## RESPONSE TO AUDIT ISSUES

### APR1400 Topical Reports

Review Section	TR Realistic Evaluation Methodology for LBLOCA of the APR1400
Application Section	Topical Report: APR1400-F-A-TR-12004 Realistic Evaluation Methodology for Large-Break LOCA of the APR1400
Issue Date	08/13/2015

### **Audit Issues No. 5**

Figure 3. The effect of the noding sensitivity

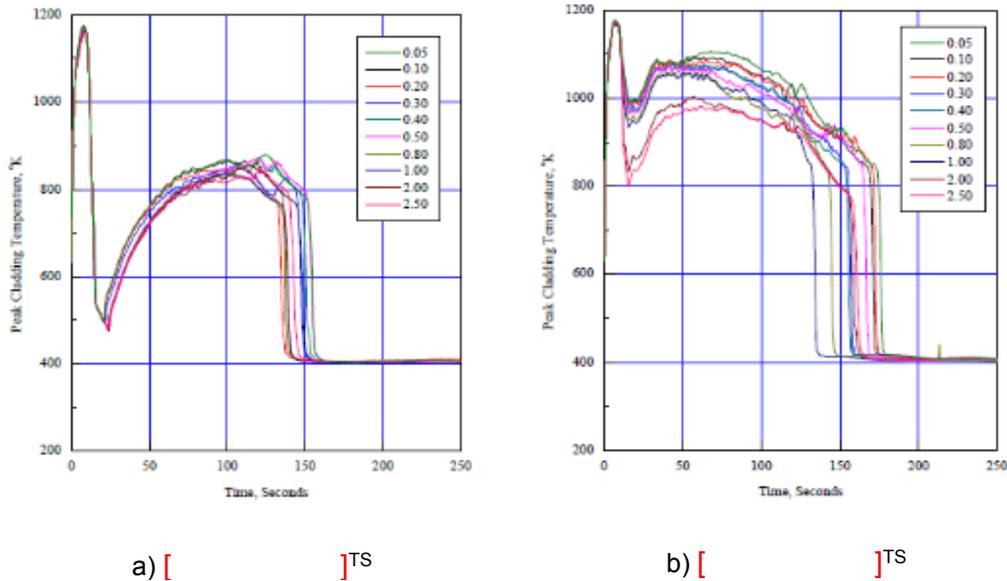
The guidance in RG 1.157, Section 4.3.1 establishes acceptable controls for the utilization of conservative parameters in best estimate analysis. The topical report states that the methodology is best-estimate. However, the actual implementation of the methodology incorporates a mixture of best-estimate and conservative assumptions. The reason for the conservative treatment is provided for only certain parameters. The Applicant will need to provide the basis and justifications for the selecting the parameters to be treated conservatively instead of a best-estimate manner, involving the quantification and propagation of uncertainties.

The upper head water can flow down to the upper plenum and may affect the core cooling behavior during blowdown. This phenomenon is considered by the nodding scheme. By performing several sensitivity studies on the nodalization of upper guide structure (UGS, the volume between upper guide structure support plate and inner vessel assembly), the nodding that gives the most conservative result is determined. The limiting UGS nodding is used for the plant calculation of the topical report. Figure 1 and Figure 2 show the conventional nodding scheme and the most conservative nodding scheme, respectively. Figure 3 shows the effect of the nodding scheme on the cladding temperature. Although reflood PCT is changed more, the phenomenon is important for blowdown because the phenomenon is related with blowdown quenching. The category of conservatism of this phenomenon belongs to Category 2.
